Access Compliance Report Public Rights-of-Way (Transit Stops)

Intersection ID: 10035417	Main Street: RANDOLPH_RD	Cross Street: N/A	Location: SW
ADA ID: 66D4674C6522	Overall Compliance: No	Severity Score: 35

CATS Stop ID: **23710**

CATS Stop Description: **Randolph Rd & Museum Plaza**

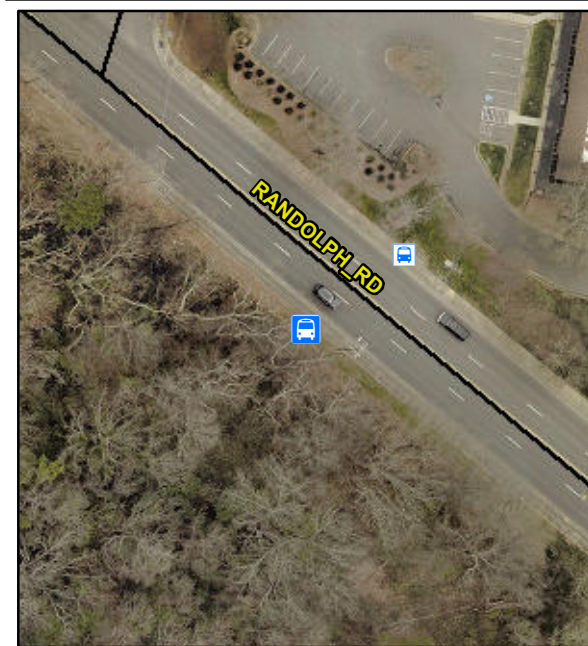
Compliance	Description	Data
Yes	Boarding Area	Yes
Yes	Boarding Area Width (in)	63.0
Yes	Boarding Area Length (in)	96.0
Yes	Boarding Area Slope %	0.0
Yes	Boarding Area XSlope %	3.2
No	PAR 1 Exist?	Yes
Yes	PAR 1 Width (in)	73.0
No	PAR 1 Slope %	4.1
Yes	PAR 1 XSlope %	0.6
N/A	PAR 1 XSlope Location	Perp
No	PAR 2 Exist?	Yes
Yes	PAR 2 Width (in)	73.0
Yes	PAR 2 Slope %	2.8
No	PAR 2 XSlope %	2.8
N/A	PAR 2 XSlope Location	Perp
Yes	Boarding Area Connected to PAR?	Yes
N/A	Road Slope %	3.8
N/A	Shelter	No
No	Clear Floor Space	Yes
N/A	Clear Floor Space Shelter	No
Yes	Clear Floor Space Width (in)	73.0
No	Clear Floor Space Length (in)	35.0
No	Clear Floor Space Slope %	2.3
No	Clear Floor Space XSlope %	4.2
N/A	Alcove Condition?	No
Yes	Transit Sign?	Yes
Yes	Transit Sign Height (in)	97.0
N/A	Bench?	Yes
Yes	Protruding Objects?	No

Remove & Replace Sidewalk To Boarding Area. Remove & Replace Clear Floor Space.
